Project	IEEE 802.16 Broadband Wireless Access Working Group < http://ieee802.org/16 >
Title	Re-definition of Mobile Terminal Management Primitives
Date Submitted	2007-03-08
Source(s)	Jaesun Cha and Chulsik Yoon jscha@etri.re.kr ETRI 161 Gajeong-dong, Yuseong-gu Daejeon 305-700 Korea
Re:	Contribution on comments to IEEE 802.16g/D8
Abstract	Re-definition of mobile terminal management primitives
Purpose	Adoption
Notice	This document has been prepared to assist IEEE 802.16. It is offered as a basis for discussion and is not binding on the contributing individual(s) or organization(s). The material in this document is subject to change in form and content after further study. The contributor(s) reserve(s) the right to add, amend or withdraw material contained herein.
Release	The contributor grants a free, irrevocable license to the IEEE to incorporate text contained in this contribution, and any modifications thereof, in the creation of an IEEE Standards publication; to copyright in the IEEE's name any IEEE Standards publication even though it may include portions of this contribution; and at the IEEE's sole discretion to permit others to reproduce in whole or in part the resulting IEEE

Figure 505 – M-MTM primitives flow for Reset / Power On/Power Down at MSSS side

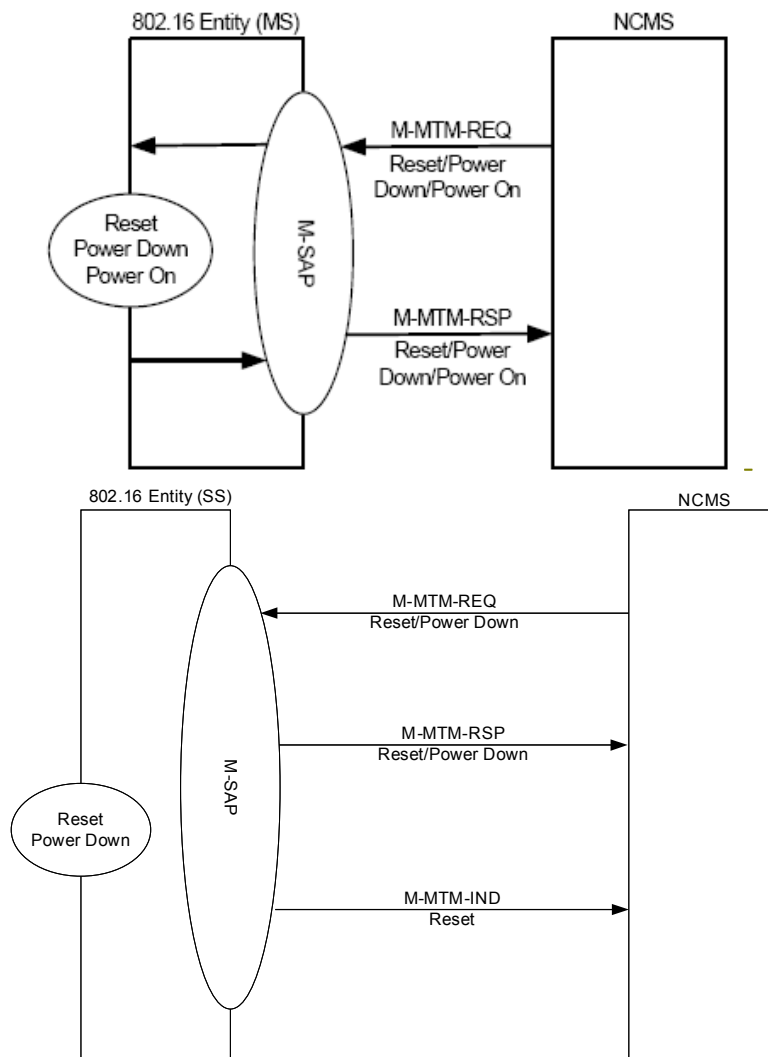
Some of mobile terminal management primitives are not defined correctly. For example, M-MTM-REQ (Power On) primitive is generated to force the terminal to power on. But, the terminal can not receive the primitive because it has already been powered off.

Primitives	Changes	Reason for Changes
M-MTM-REQ (Power on) M-MTM-RSP (Power on)	<ul style="list-style-type: none"> ➤ Remove two primitives ➤ Add a new primitive; M-MTM-IND (Power On) 	<ul style="list-style-type: none"> ➤ We can't give any instruction to the device which is powered off.
M-MTM-REQ (Power Down) M-MTM-RSP (Power Down)	<ul style="list-style-type: none"> ➤ The SS generates M-MTM-RSP (Power Down) primitives before it starts power-down procedure. 	<ul style="list-style-type: none"> ➤ After power-down, the SS can't generate any primitive.
M-MTM-REQ (Reset) M-MTM-RSP (Reset)	<ul style="list-style-type: none"> ➤ If NCMS at SS side generates the request primitive, the SS performs reset procedure after it responds to the request. And then, it generates M-MTM-IND (reset) primitive to notify the NCMS of the completion of reset. ➤ If NCMS at BS side uses M-MTM-REQ (reset) primitive instead of M-MTM-IND (reset) primitive to reset the terminal 	<ul style="list-style-type: none"> ➤ It's better to use one unified primitive to notify the NCMS of a reset event; M-MTM-IND (reset) ➤ The generation of M-MTM-IND (reset) by the NCMS at BS side is not the event notification. It's just a request to reset the terminal

Figure 507 – M-MTM primitives flow for Hold and Normal resumption

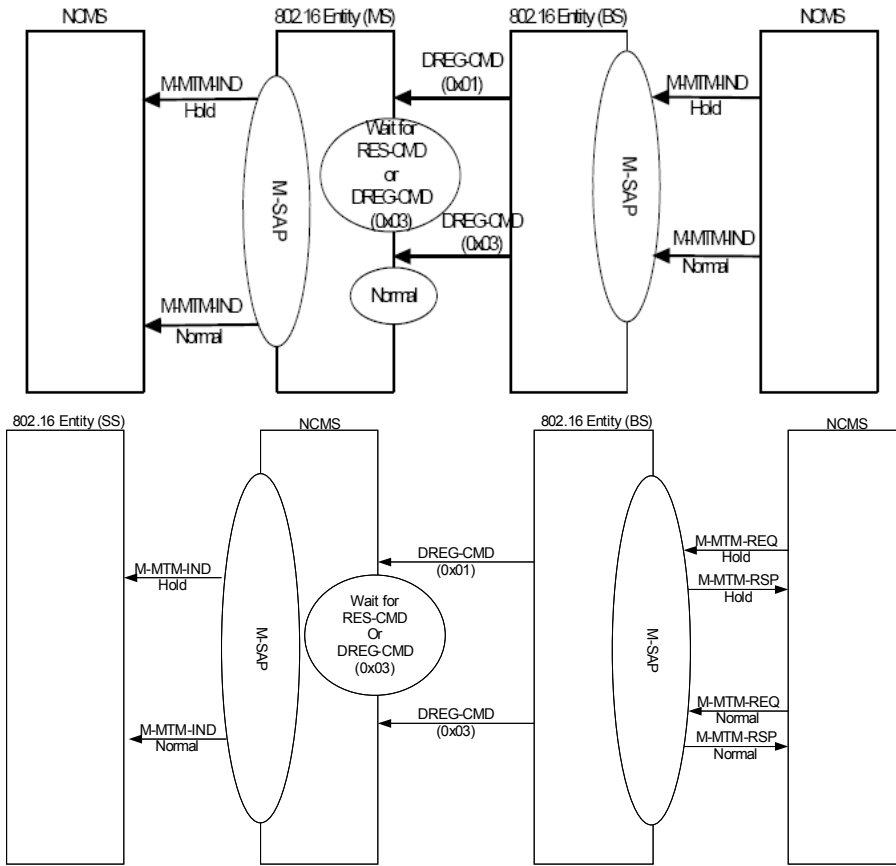
Another example is the primitives used to change the status of the terminal. Generally, an indication primitive is used to notify any event. But, in the current draft, the NCMS uses an indication primitive to request the terminal to change the current status.

M-MTM-IND (Hold)	<ul style="list-style-type: none"> ➤ Only SS can generate M-MTM-IND (Hold) primitive. ➤ The new primitives are used at BS side; M-MTM-REQ (Hold), M-MTM-RSP (Hold) 	<ul style="list-style-type: none"> ➤ The generation of M-MTM-IND (Hold) by the NCMS at BS side is not the event notification. It's just a request to change the status of the terminal
M-MTM-IND (Normal)	<ul style="list-style-type: none"> ➤ Only SS can generate M-MTM-IND (Normal) primitive. ➤ The new primitives are used at BS side; M-MTM-REQ (Normal), M-MTM-RSP (Normal) 	<ul style="list-style-type: none"> ➤ The generation of M-MTM-IND (Normal) by the NCMS at BS side is not the event notification. It's just a request to change the status of the terminal
